Product Change Notification

Change Notification #: 114578 - 00
Change Title: Intel® Server System R2224GZ4GC4
PCN 114578 - 00,
Product Design,
Air duct improvement
Date of Publication: May 06, 2016

New air duct lock hook

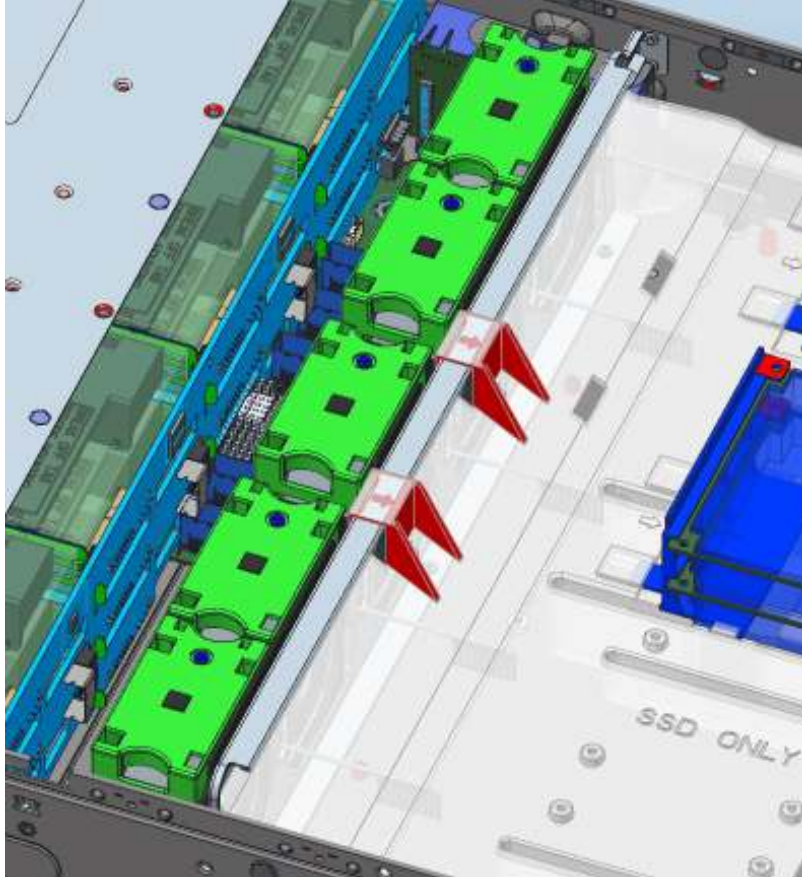
1. Change air duct lock feature: Change air duct lock hook so the air duct will hook over the FAN bulkhead. This will improve the fixing of air duct during transportation.
